Chatfield Farms Active Adult Community

Beacon Falls, Connecticut

King's Mark Environmental Review Team Report

July 2004

Figure 4

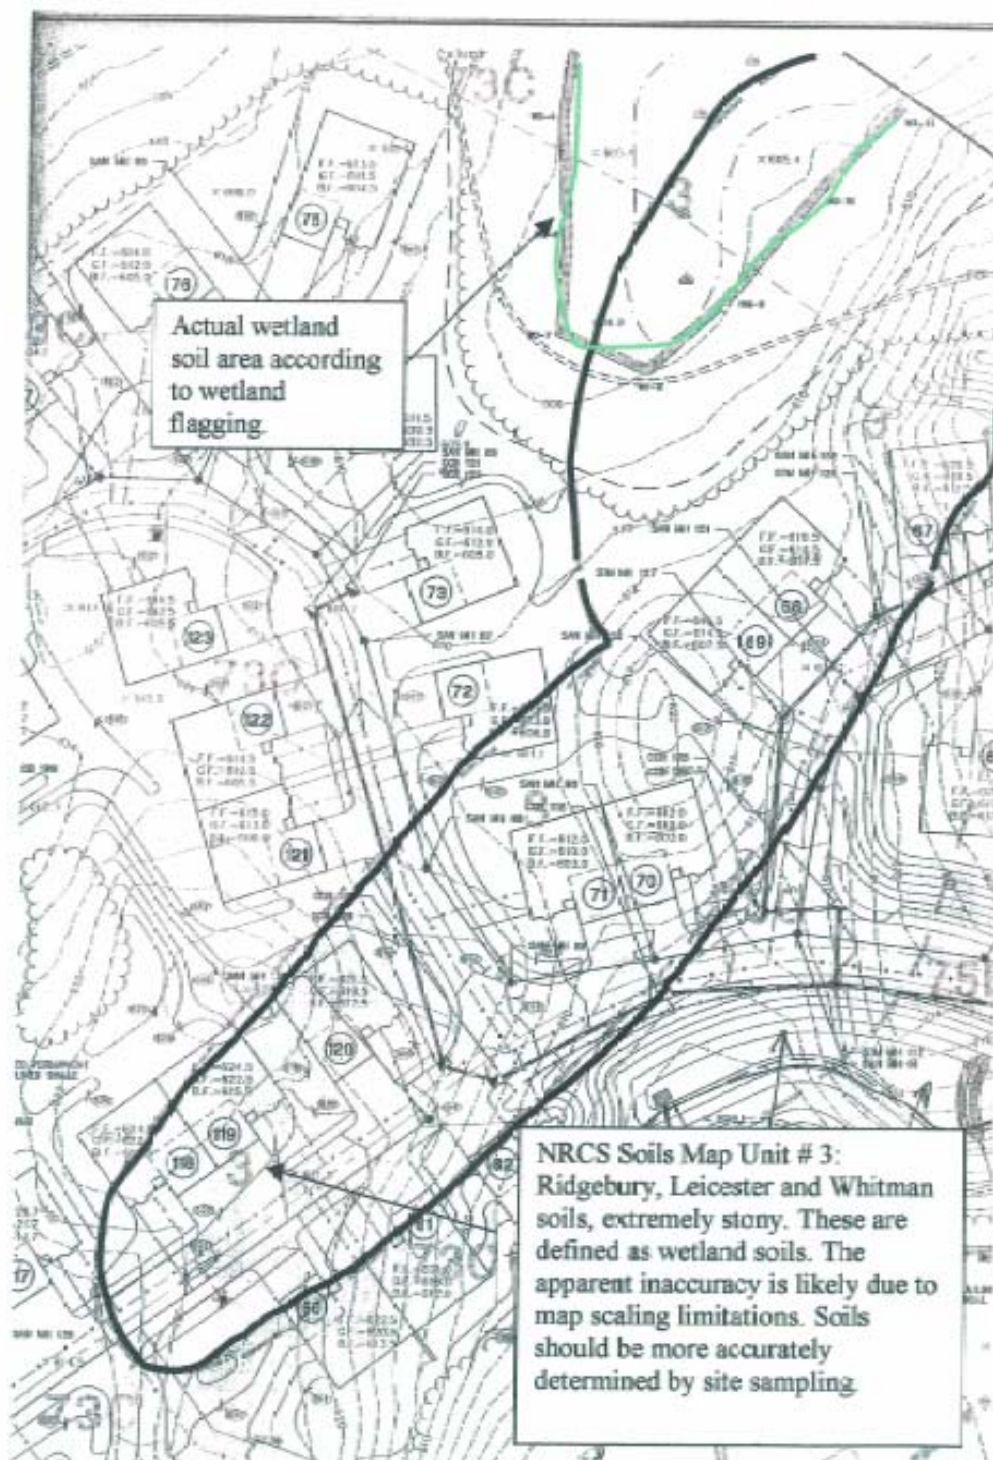
Soils information on the site plans provided is inadequate for determining specific site conditions. USDA New Haven County Soil Survey soil delineations (apparently the source of the delineations for the site plan of this project) are not on a scale (1:15,840 scale projected onto a 1:480 scale map compounds any soil type border inaccuracy by 33 times) that supports the determination of specific soil types that may be included in the soil complexes indicated. (New Haven County Soil Survey page 3). For example, there is an area on the northeast section of the site indicated as an area of Ridgebury, Leicester and Whitman extremely stony soils that the site plan shows developed with a number of housing units. The probability is that the entire area delineated as these hydric soils are in fact not this soil type at all, but it is not possible to tell from the information provided. From the site plan, one would conclude that a number of residential units are to be built within a wetland. See Figure 4.

Figure 5

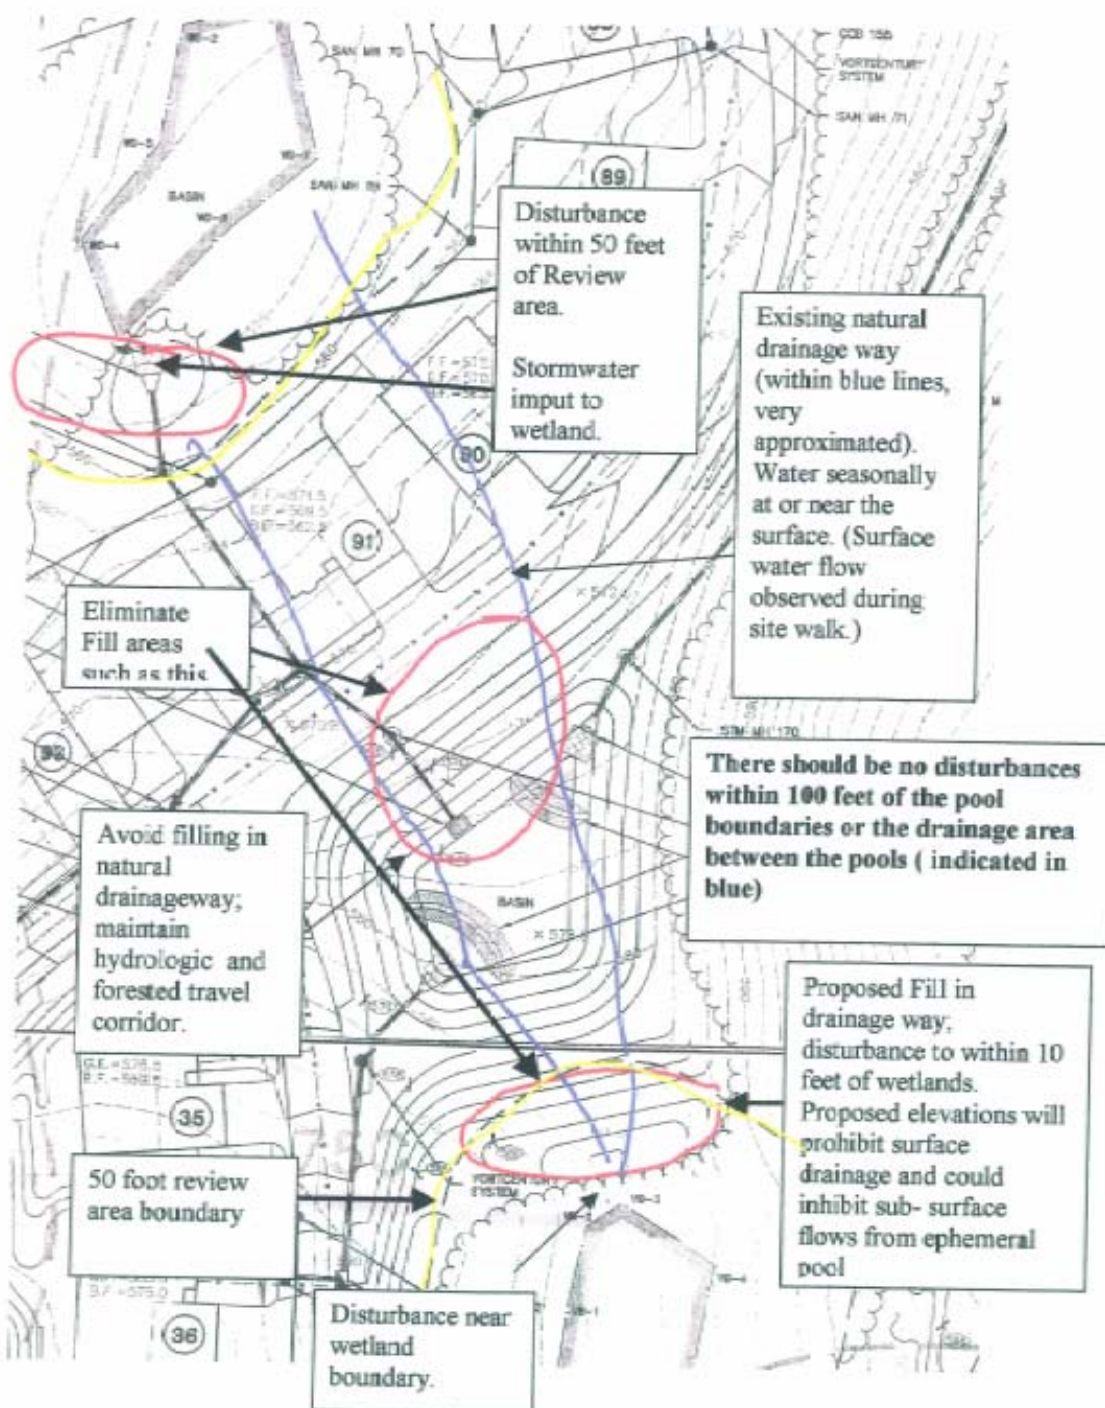
When soils are removed or bedrock blasted, the ground water flows are likely to be affected. Likewise filling in depressions and drainage ways can alter near surface or intermittent surface water flows. All of these alterations can then effect changes to nearby plant and animal populations. Also, seeps can result from the interception of the water table especially in shallow to bedrock areas and areas of irregular topographic features. Finally disturbed or fill soils can be more compacted then preexisting soil conditions impeding near surface ground water flows. An example of filling in a drainageway is indicated in Figure 5.

"Vernal Pool depressions should never be used, either temporarily or permanently, for stormwater detention or biofiltration." (From Calhoun & Klemens, 2002) (See Figure 5)

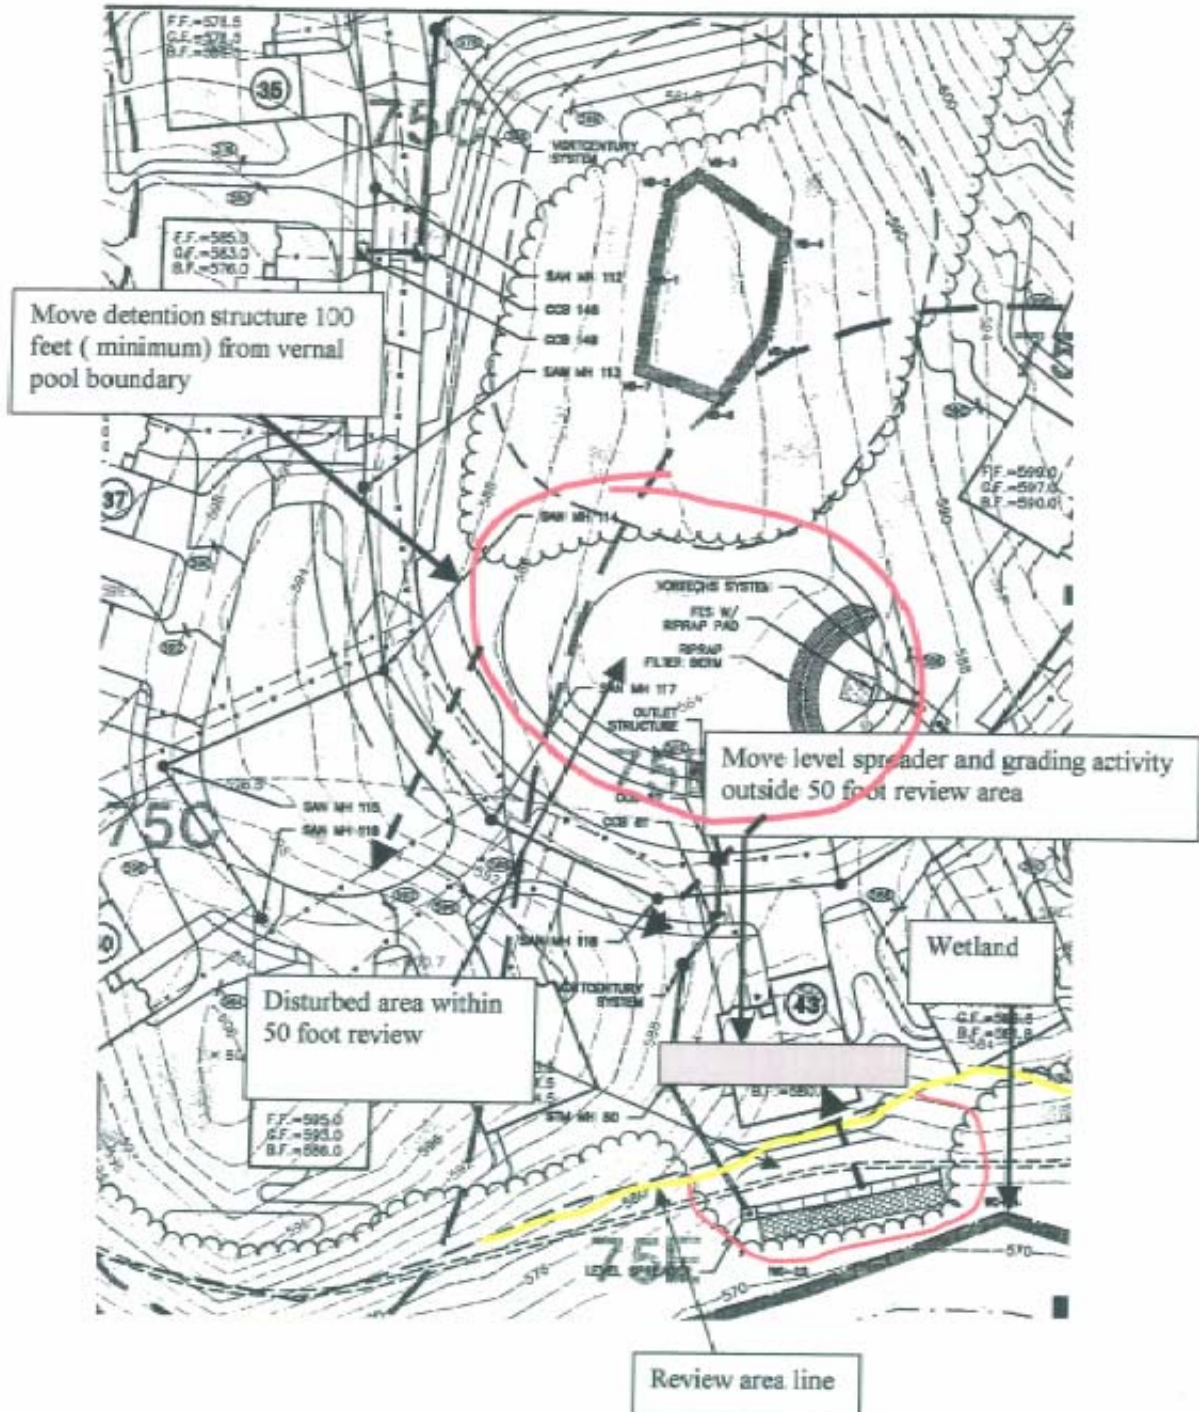
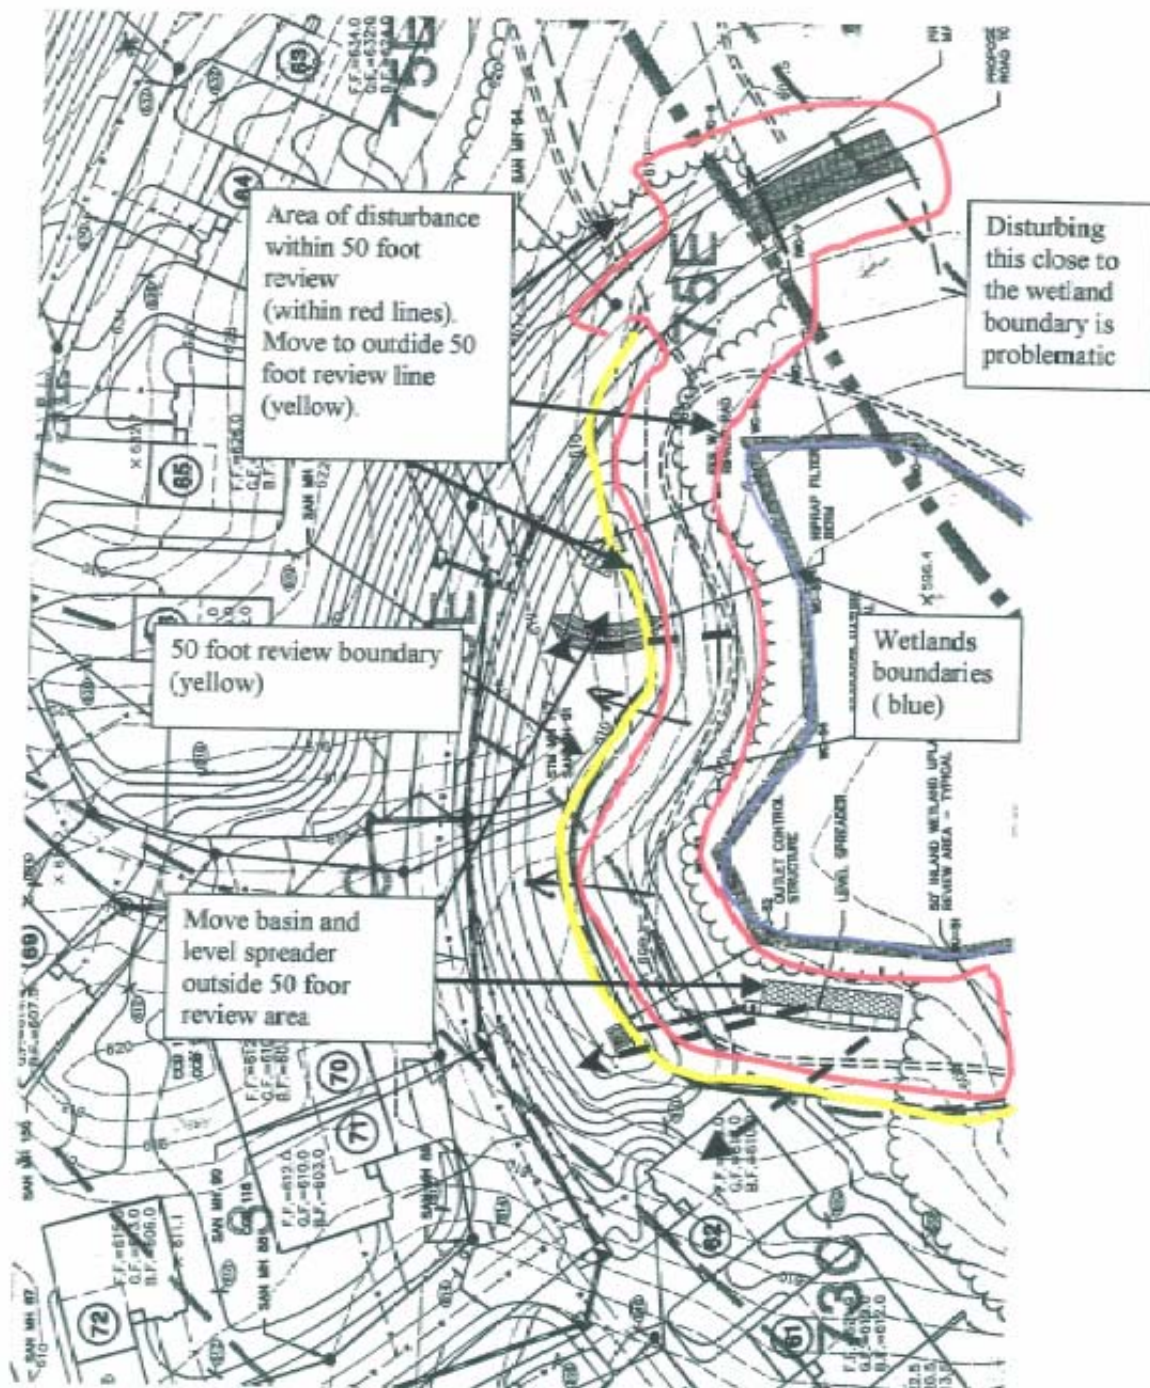
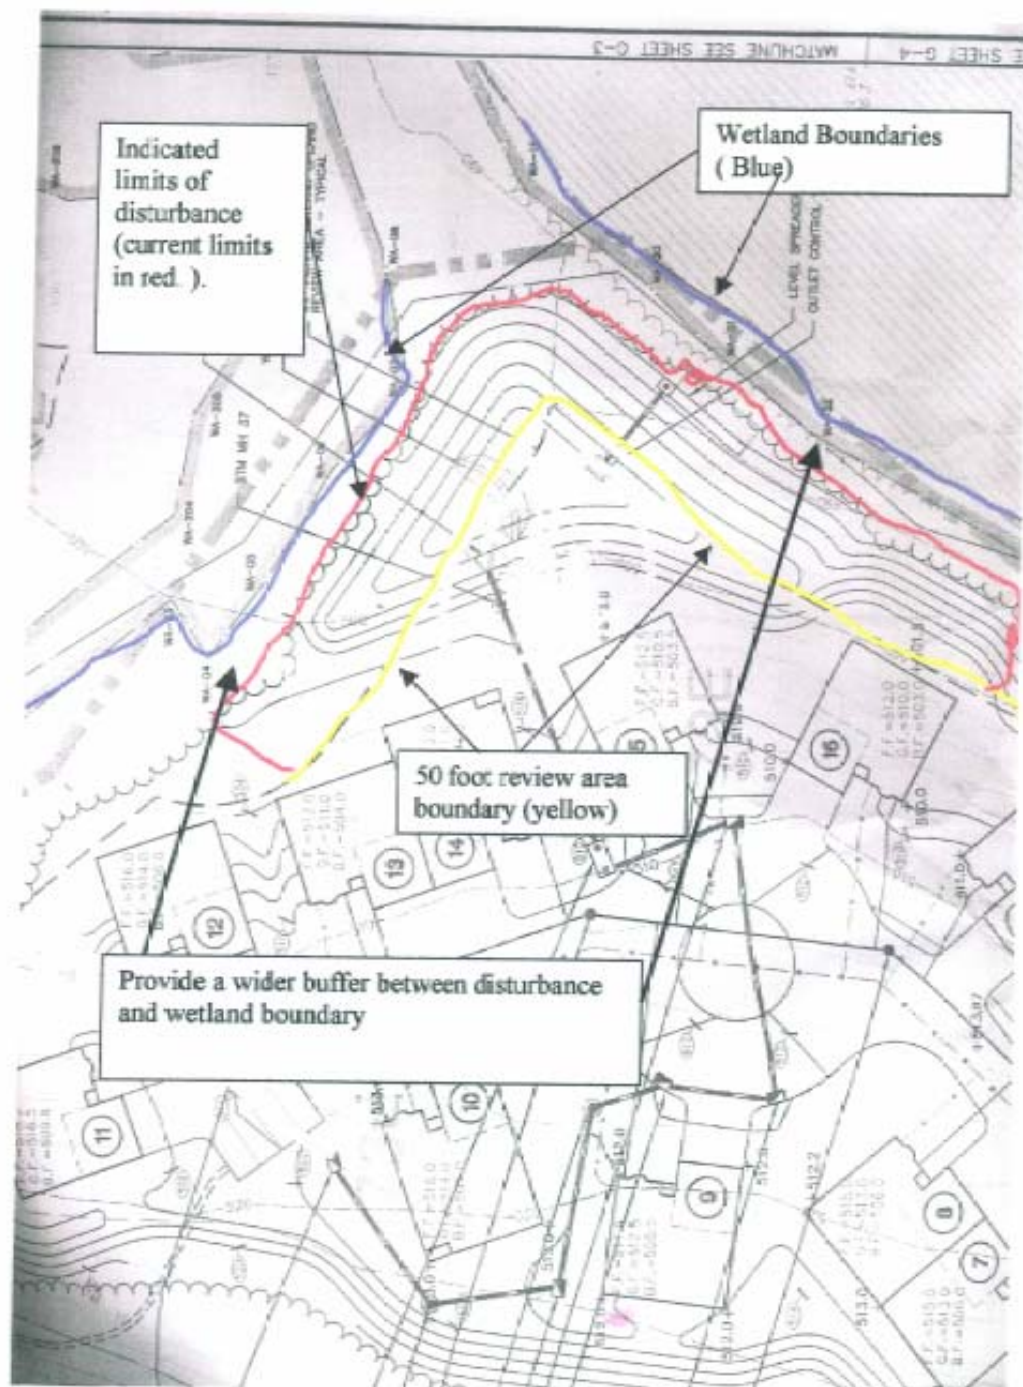
The site plan does in fact indicate that no buildings will be constructed within the 50 foot review area as stated above. However, Figures 5 through 8 detail disturbances, whether temporary or permanent, within the 50 foot wetland review area. Even though the wetland area itself is not directly disturbed in terms of soils and vegetation, the following impacts to the wetland are likely when disturbing in close proximity to the wetland boundaries:

Figure 10

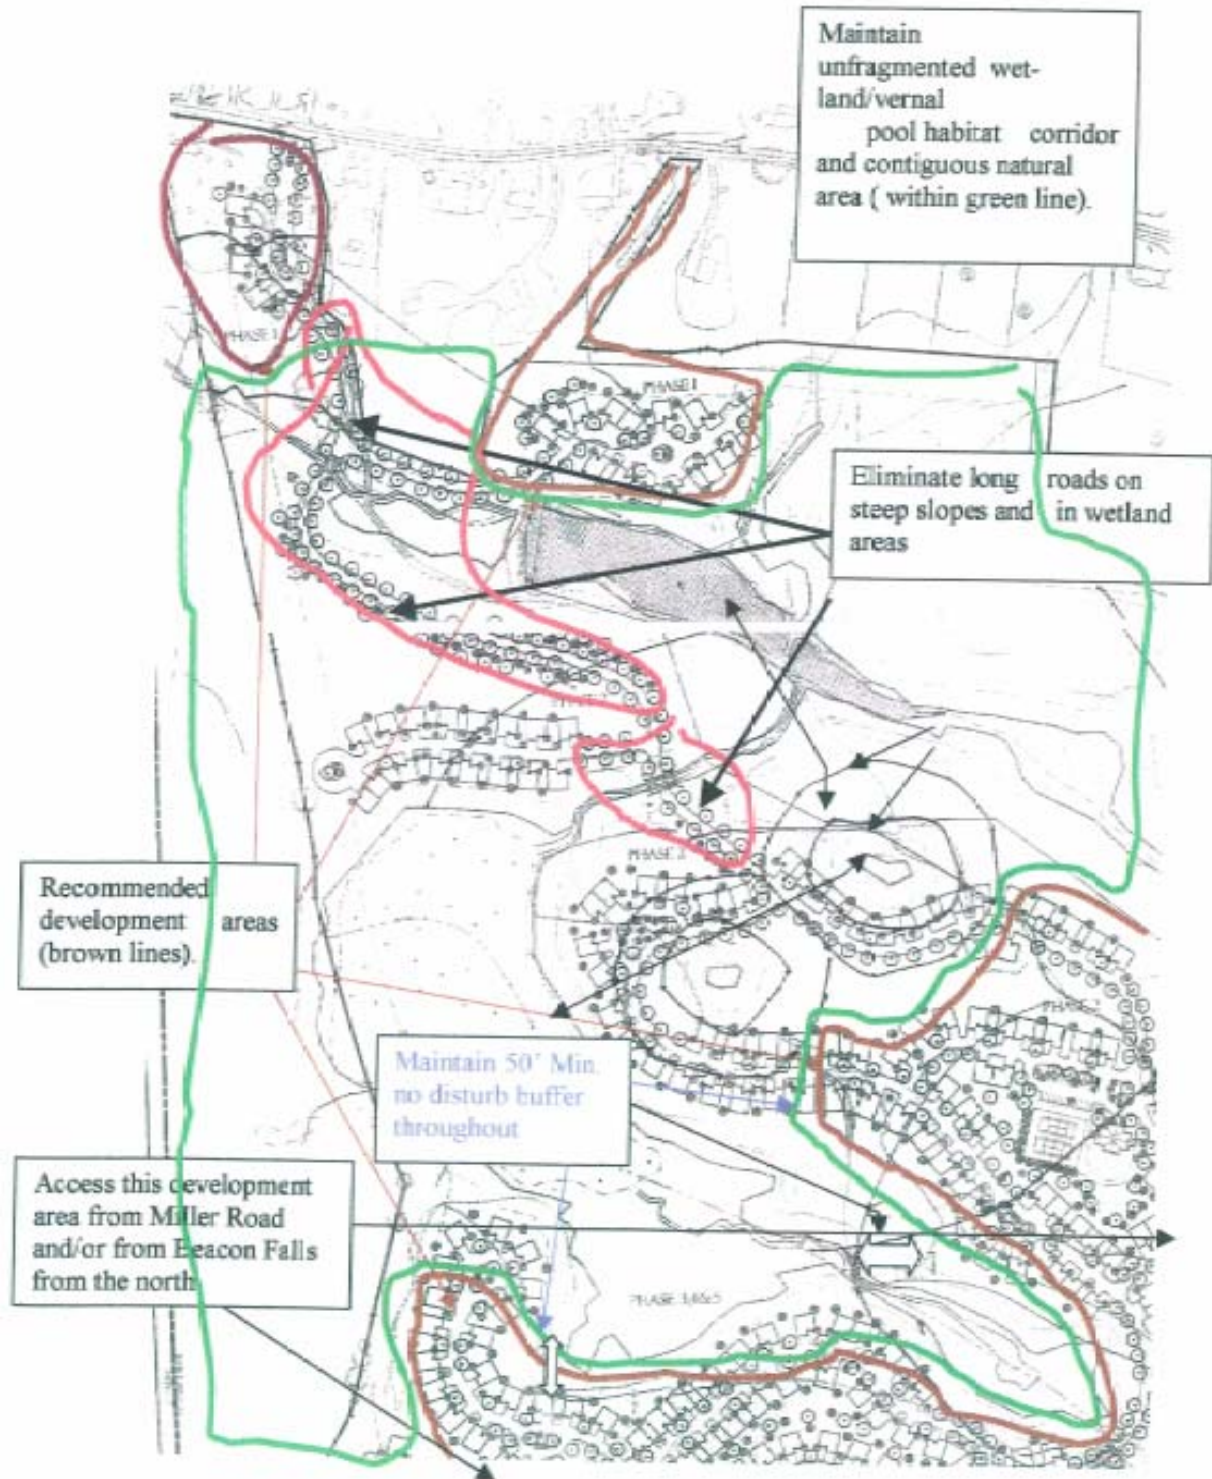
- Change site access to reduce excessive road infrastructure (see Figure 10). The plan calls for an access road with a 2000' plus length which does not directly service any housing units. The impacts of this road include the necessity for intensive winter road maintenance due to the slope, construction and maintenance of significant retaining wall structures and a large area of impervious surface. The use of road sand and salt for winter road maintenance can negatively impact wetlands and watercourses. The most effective means for reducing this impact is by reducing the total lengths of road through site design changes, limiting the amount of winter time driving and the need to have dry pavement, and by reducing the amount of sand and salt used by utilizing appropriate management practices. The Southwest Conservation District's report "Norwalk River Watershed Road Sand/Salt Reduction Project" outlines some of these possibilities and is available on CD-ROM from the District.

- 5) Show limit of disturbance lines on plans. Minimize total site disturbance leaving existing natural vegetation wherever possible.
- 6) Change site access to reduce excessive road infrastructure (see Figure 10).
